工程指示編號：EI/0757/19

工程編號：J837 平台

工程名稱：觀塘 裕民坊平台

工程項目：安排地盤驗焊和驗拉爆 (Skylight 項目)

# SkyLight BD drawing

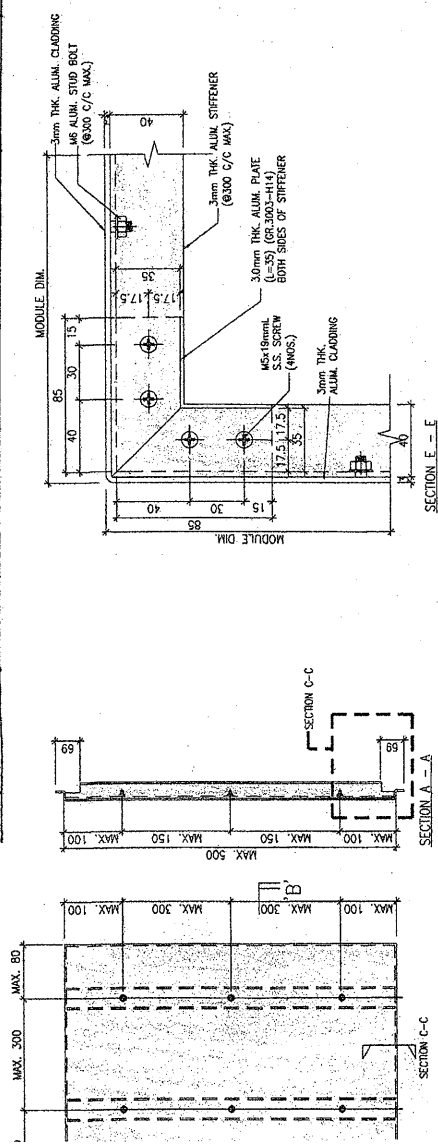
地盤驗焊 100%目測、20%磁粉

地盤驗拉爆 M12 HST3-R 10 粒 Test Load :10.05kN 2 分鐘

地盤驗拉爆 M16 HST3-R 5 粒 Test Load :14.1kN 2 分鐘
